ITEM 7.0

CONSIDERATION OF OPTIONS WHICH MAY INCREASE THE NORTHERN SETBACK OF THE TOP LEVEL OF THE BUILDING.

WINDOW SECTION

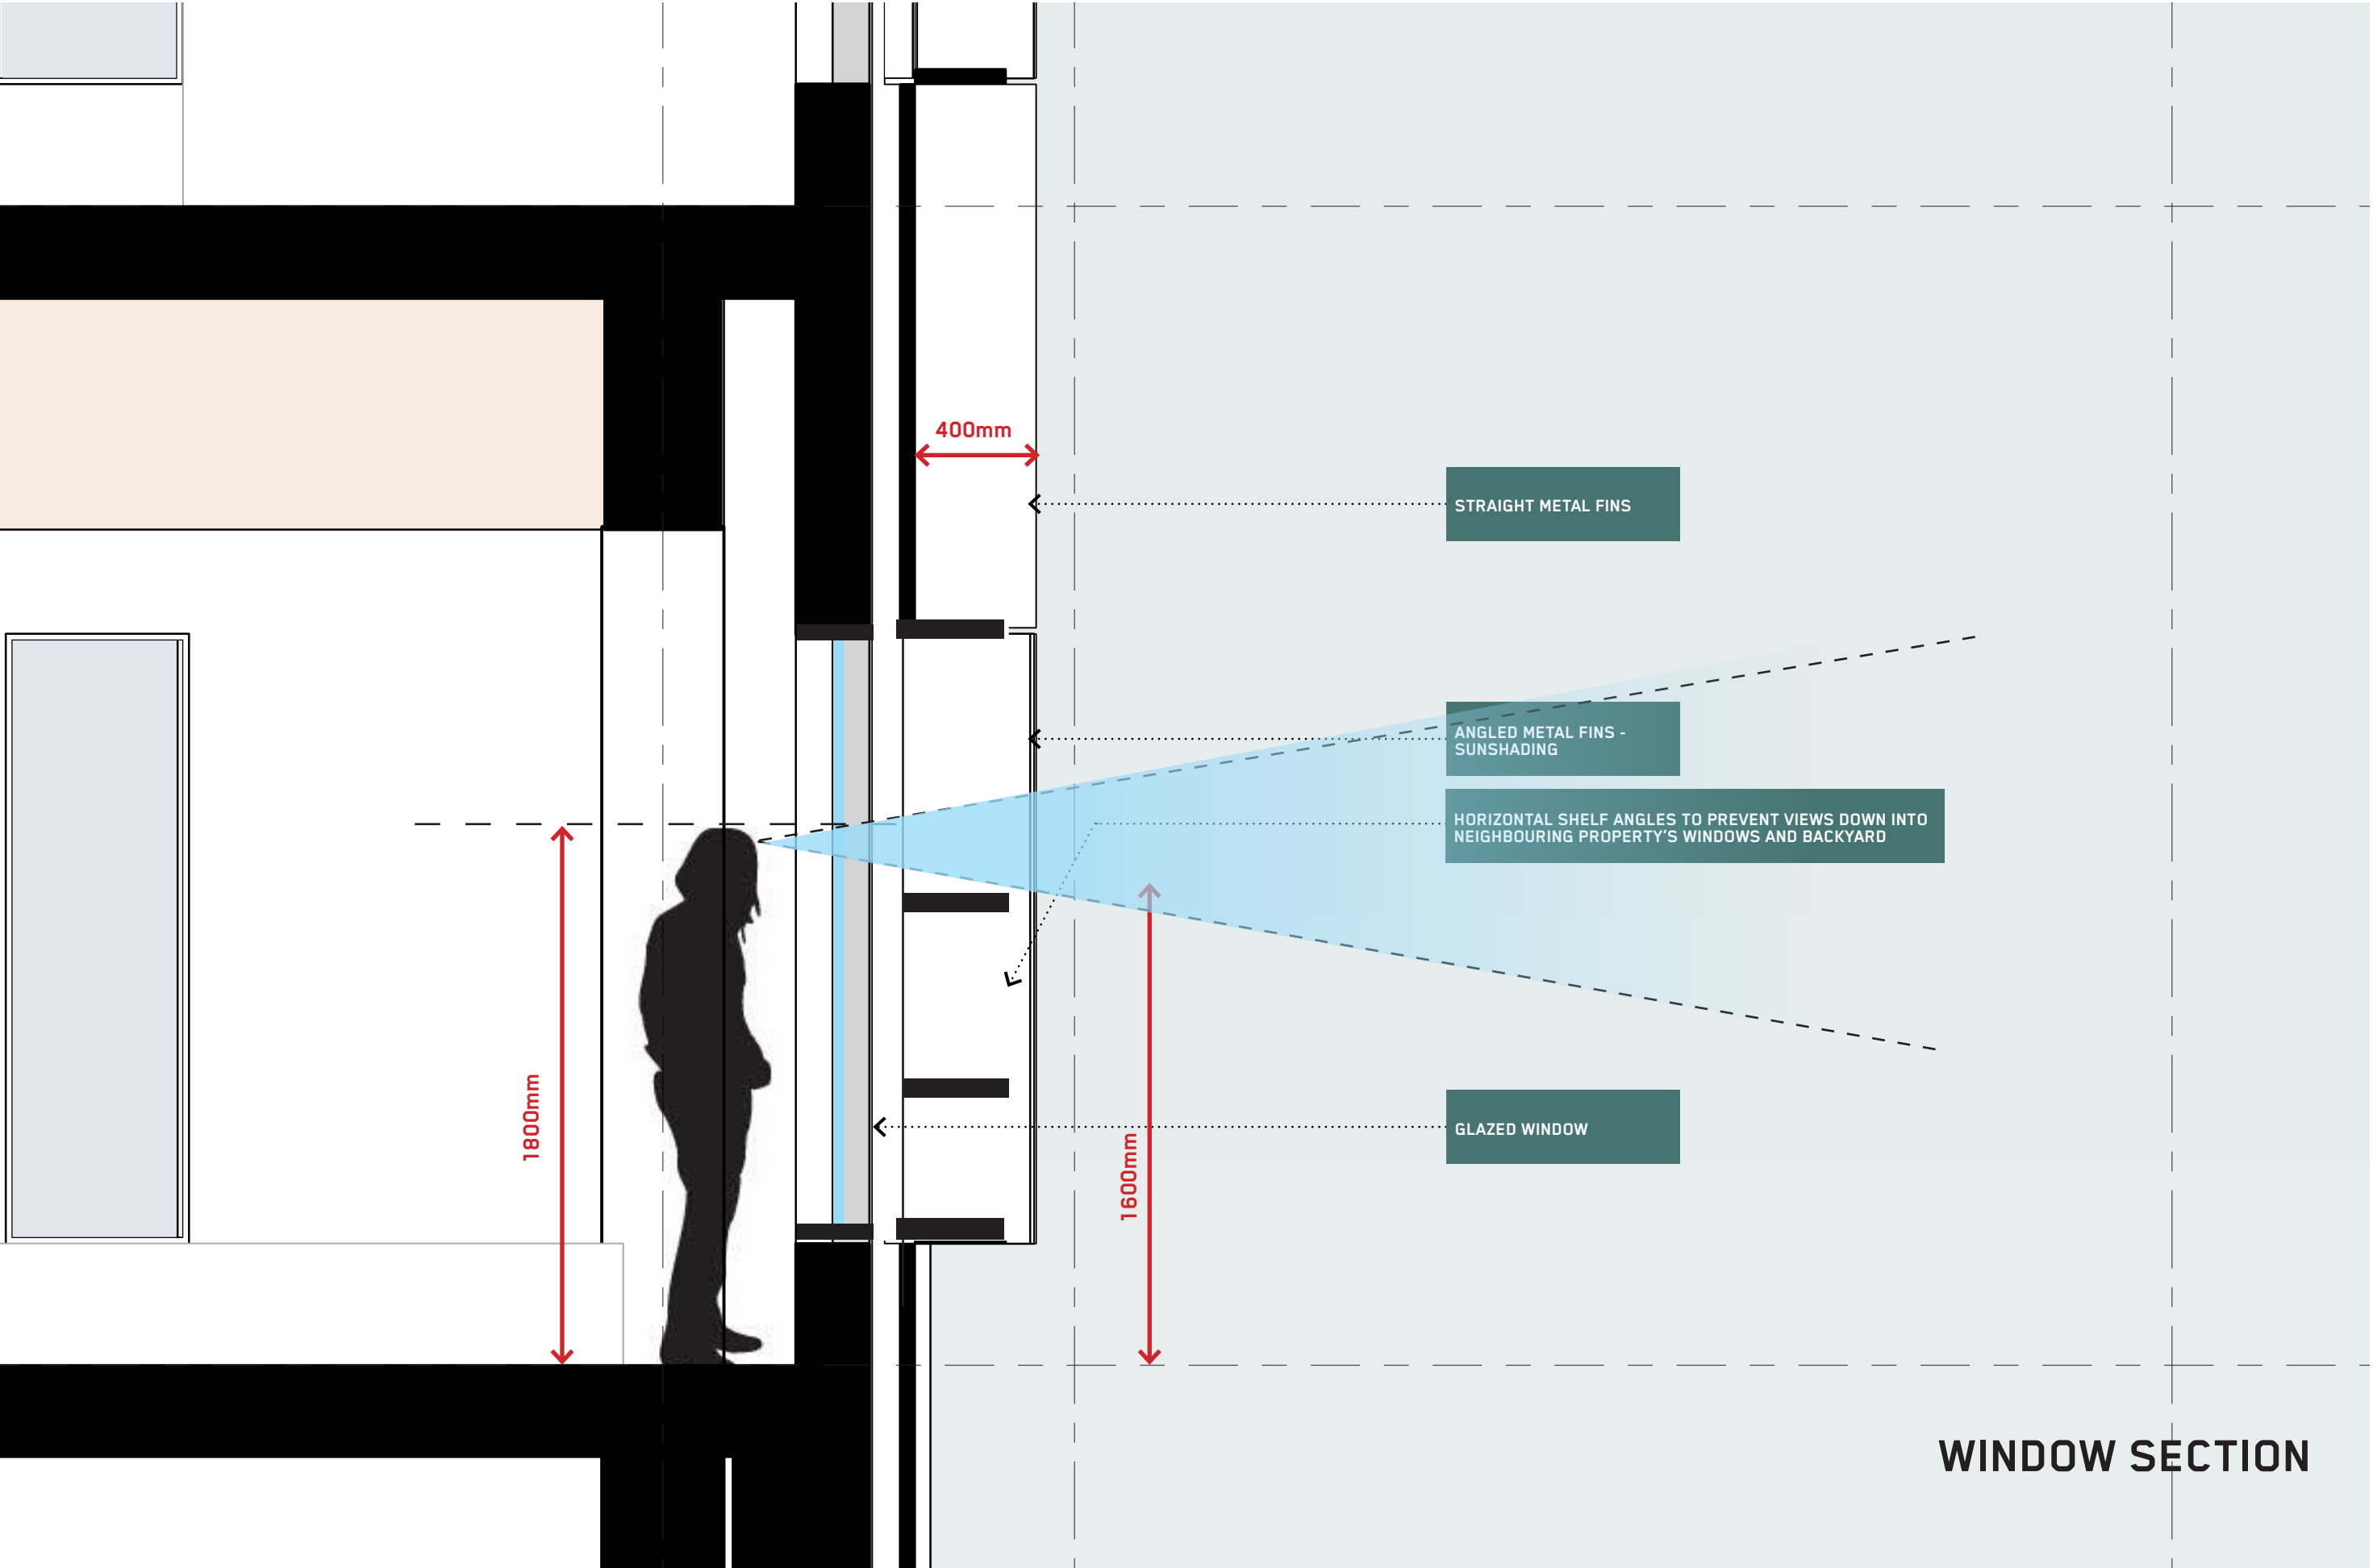
- INCREASING THE NORTHERN SETBACK WILL HAVE NO ADDITIONAL VISUAL IMPACTS DUE TO THE USE OF HORIZONTAL SHELF ANGLES
- SHELF ANGLE WILL PREVENT VISUAL LINE INTO THE NEIGHBOURING PRIVATE OPEN SPACE AT 9M SETBACK, NORTHER WINDOWS MAIN PURPOSE IS TO ALLOWING SUNLIGHT INDRECT INTO CLASSROOM SPACES.
